Joint Statement between Lancashire County Council and the Ministry of Justice

Land adjacent to HMP Garth and HMP Wymott, Ulnes Walton, Leyland

Appeal ref. APP/D2320/W/22/3295556

**Road Safety Audit
Stage 1 - Completion of Preliminary Design**

Appendix H. GARTH_ATK_HGN_A581_SK_ D_0001_P1

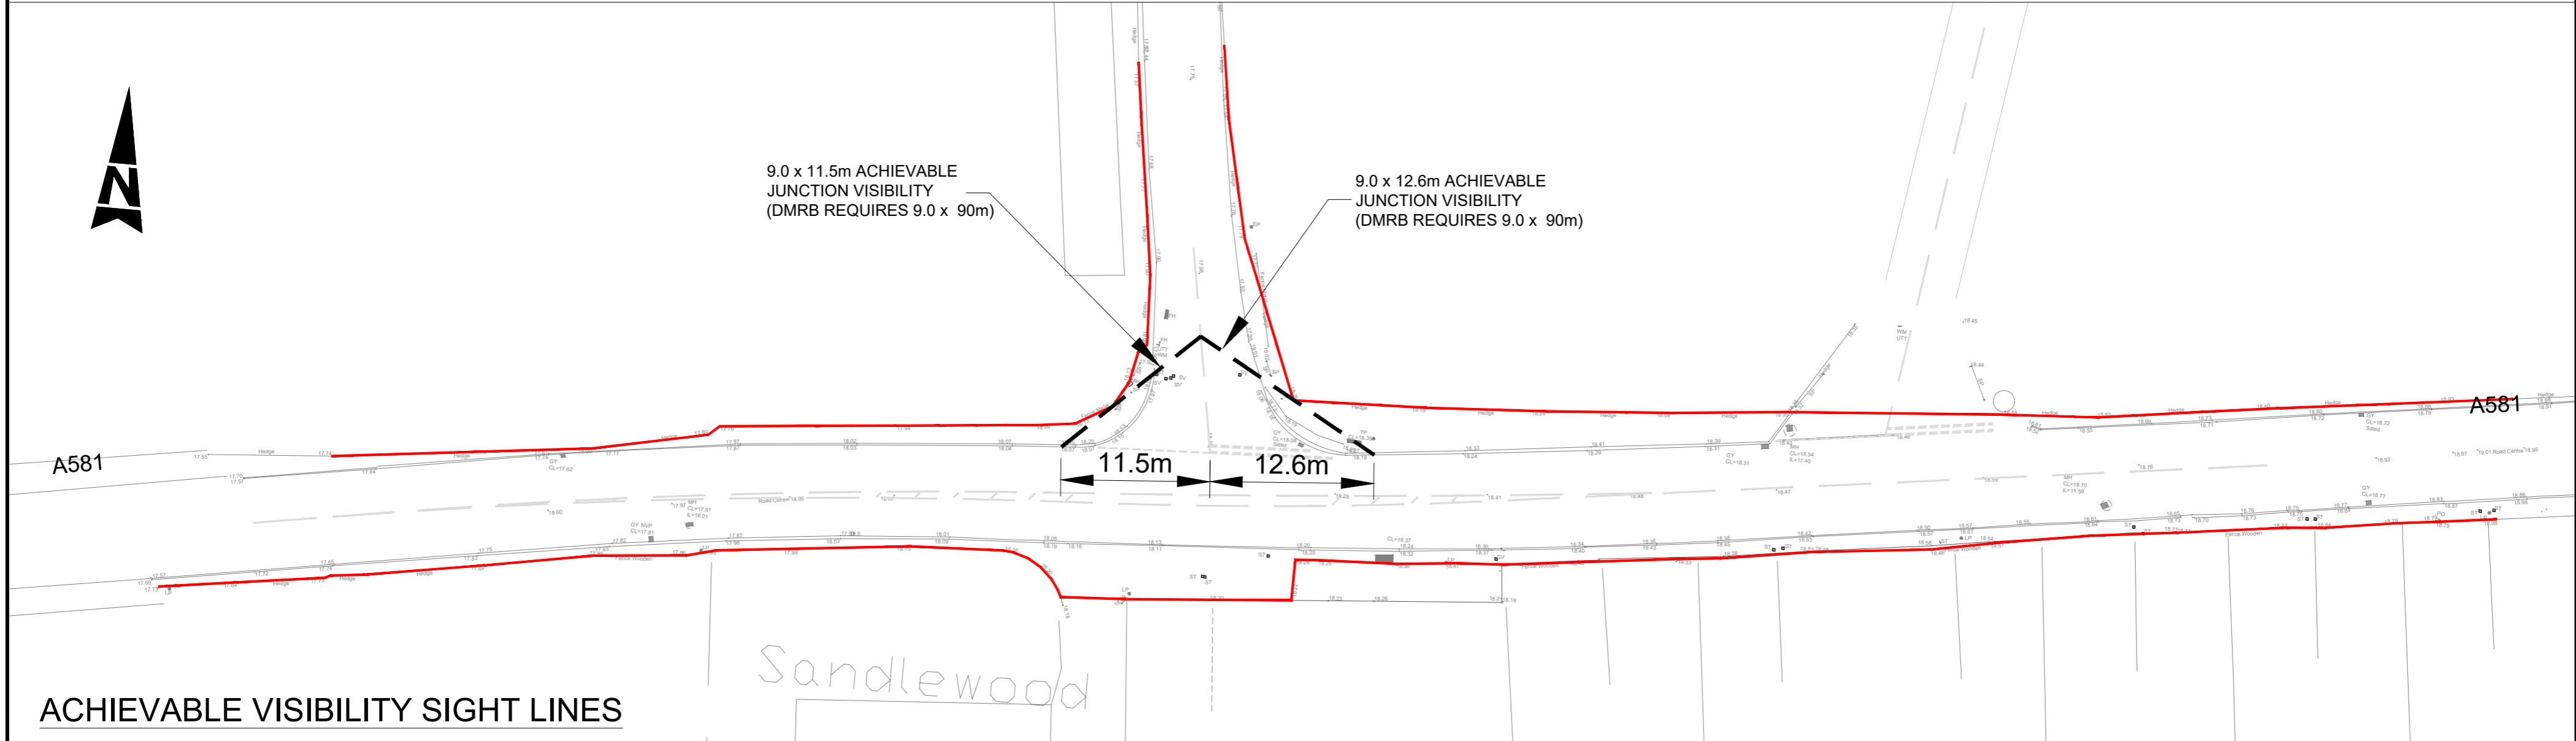
The approach from Ulnes Walton Lane at the current junction layout is similarly constrained by the boundary of the adjacent fields. Drawing GARTH_ATK_HGN_A581_SK_D_0001_P1 (Appendix H) demonstrates that the current layout fails to achieve the visibility requirements set out in DRMB CD123. The required visibility from the minor arm approach for 30mph speeds is 90m, and the advised set back distance is recommended as 9m from the give way line, which cannot be achieved within the highway boundary. The achievable visibility at a 9m setback is 12.6m to the left and 11.5m to the right.

9.0 x 11.5m ACHIEVABLE
JUNCTION VISIBILITY
(DMRB REQUIRES 9.0 x 90m)

Appendix G - GARTH_ATK_HGN_MOSS_DR_D_0002_P3

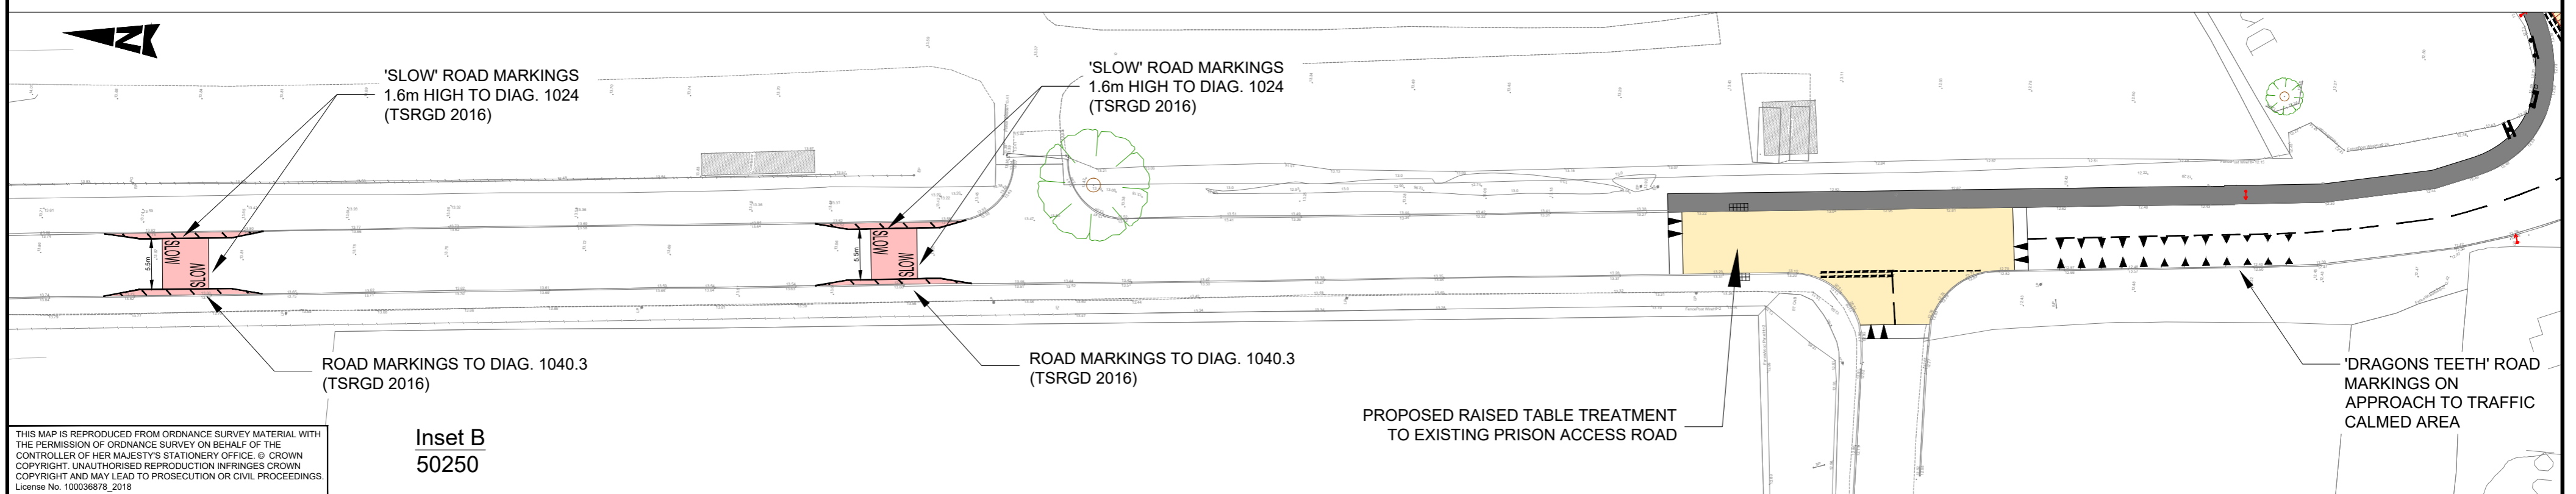
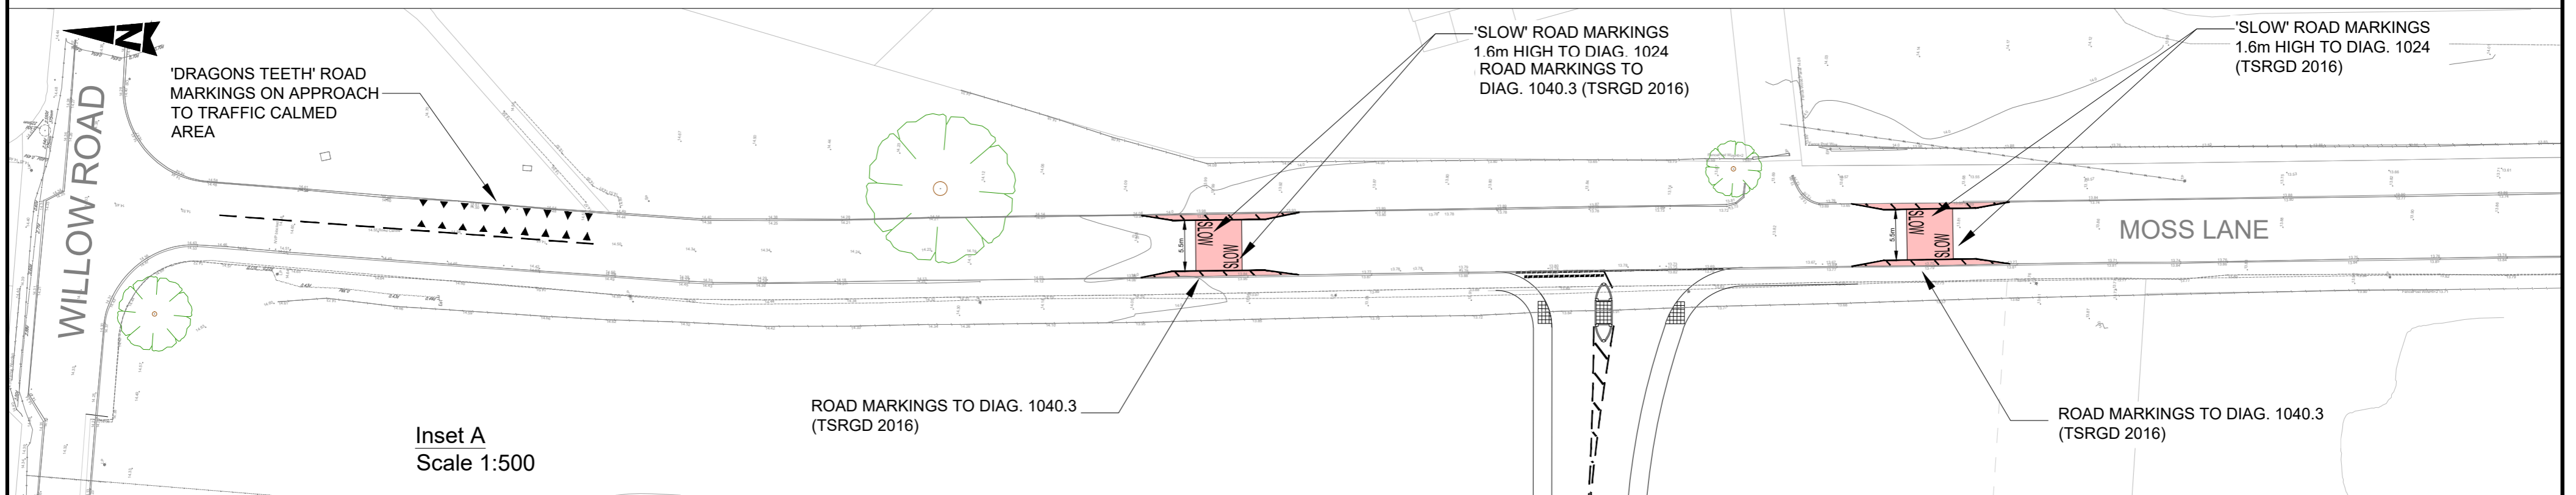
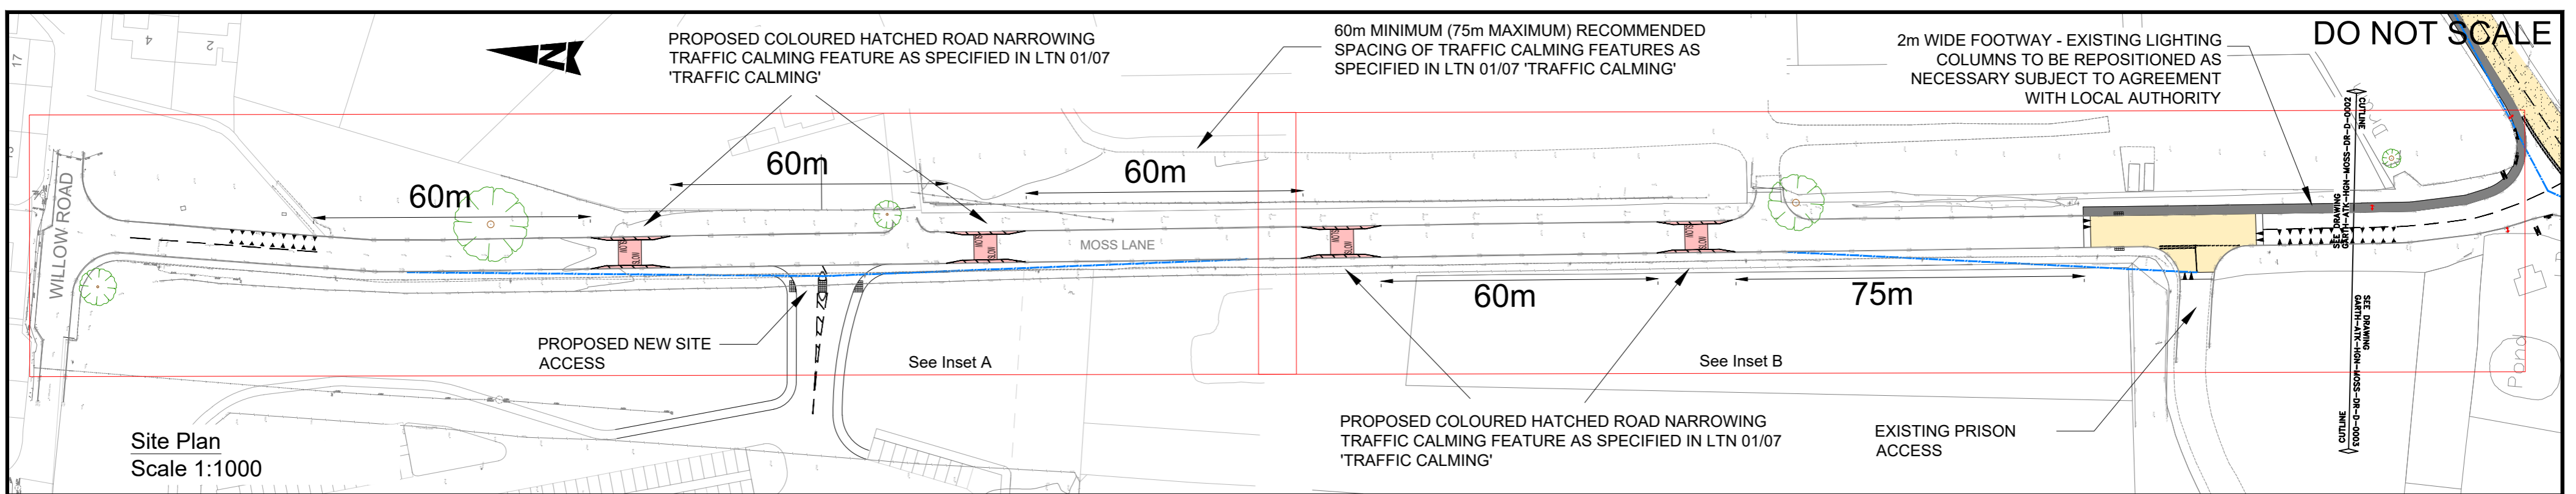
LCC have reviewed the revised and additional traffic calming measures proposed by the MoJ along Moss Lane in response to the SoS and Inspector's comments regarding potential for traffic to speed along the southern section of Moss Lane.

I have carried out a review of the proposed traffic calming measures on Moss Lane associated with Garth Wymott 2 (Drawing Garth-ATK-HGN-MOSS-DR-D-0002-P3), with respect to the potential effect on road traffic noise.

The implementation of the aforementioned traffic calming measures would result in no change to the conclusion of my noise proof of evidence (17036-HYD-PR-ACO-001-P03), prepared in June 2022 and submitted as part of the planning inquiry.
